SAS01T to SAS03T Replacement

Field Service Bulletins TSB-54-373-FTL and TSB-54-097-WST

Published : 2/4/2025

Affected Models / Truck options:

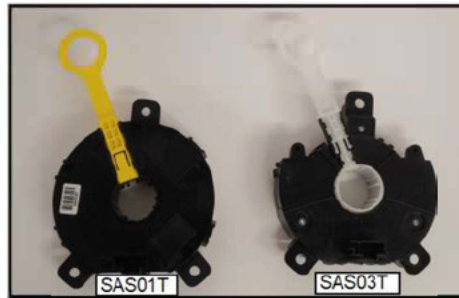
- P4, WST X Series, eM2, EP4, M2+, 108SD & 114SD+, Roughly 626,000 vehicles
- Population of affected vehicles, all vehicles built with a SAS01T From 4/18/2016 to present.
